**Joint Review Panel Request for Additional Information
Response Package
Addendum 10**

**Package 3: Geotechnical and Dam Safety, Land Use and
Land Management**

Benga Mining Limited
Grassy Mountain Coal Project

July 2019

**GRASSY MOUNTAIN MINE PLAN SHOWING BACKFILLED OPEN PIT
AND EXTERNAL WASTE ROCK DUMPS AT COMPLETION OF MINING**

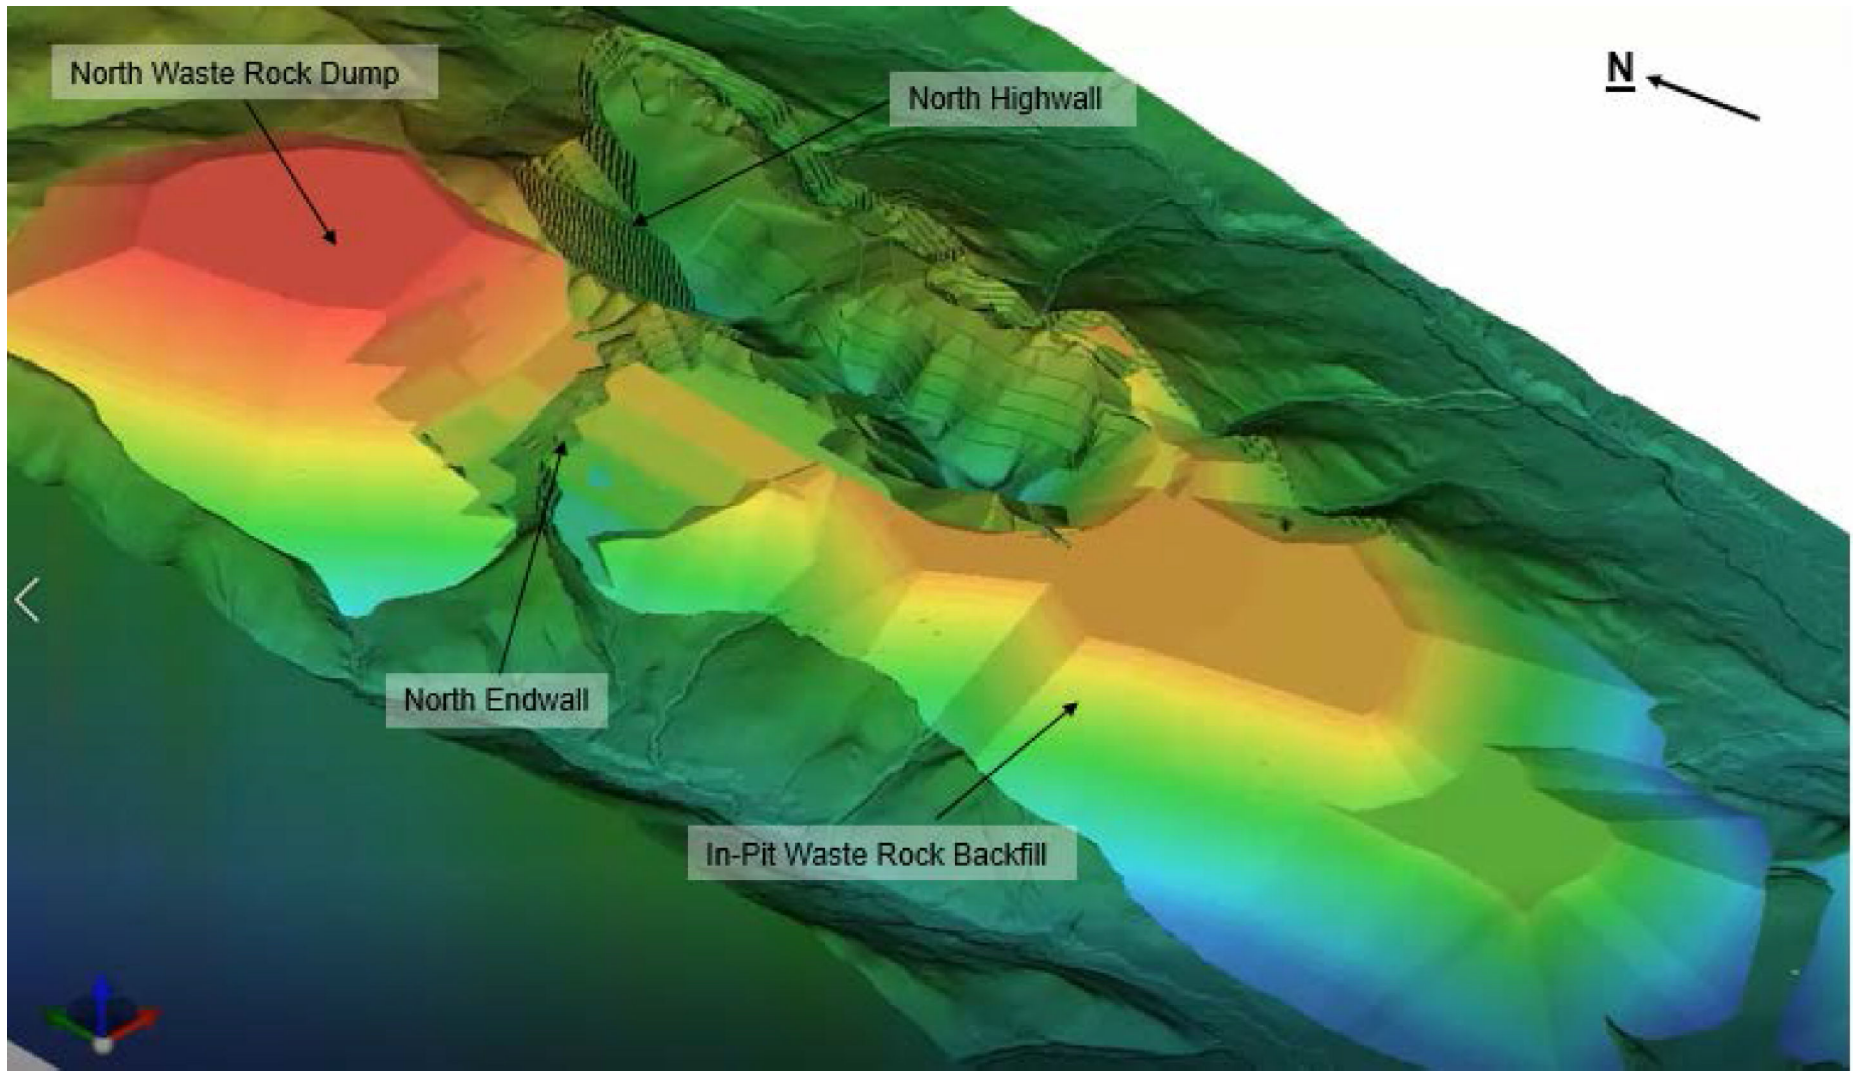
The mine plan includes a phased pit excavation and subsequent waste rock backfilling. Following the completion of some pit phases, the excavation is to be backfilled with waste rock produced from the subsequent phase. With consideration to Section 1 through the North Endwall, approximately two-thirds of the pit slope will be buttressed, and backfilling is to commence a short time after completion of excavation. There is no backfilling planned for Section 2 through the North Endwall.

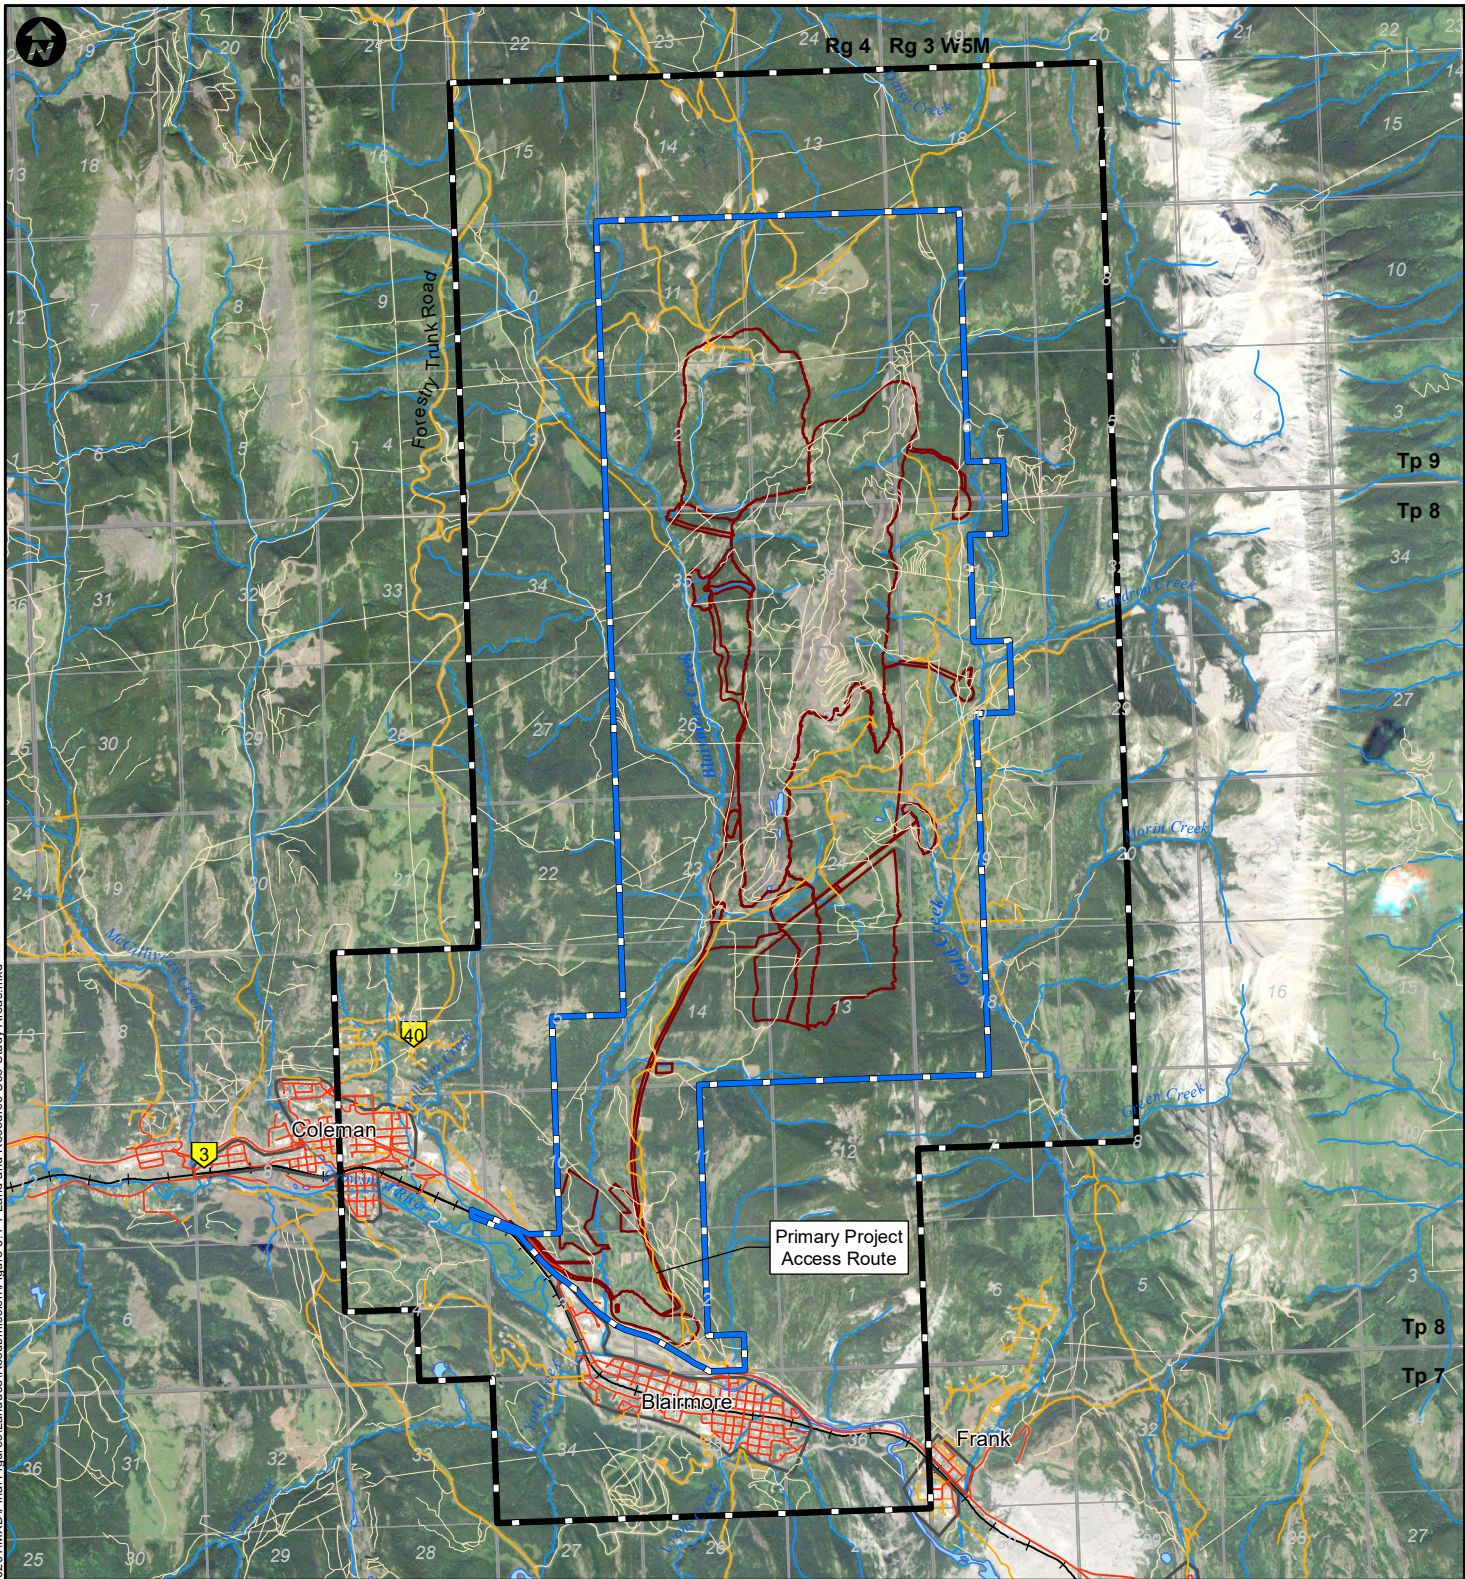
- a) Provide a map illustrating all existing and future access roads in the Land Use Regional Study Area that may be affected by the Project.

Please refer to [Figure 3.5-1](#), which illustrates the existing roads, trails, and cutlines within the Project's Land Use Regional Study Area. The Project's primary access route is the existing access road off Highway 3, immediately north of the Town of Blairmore.
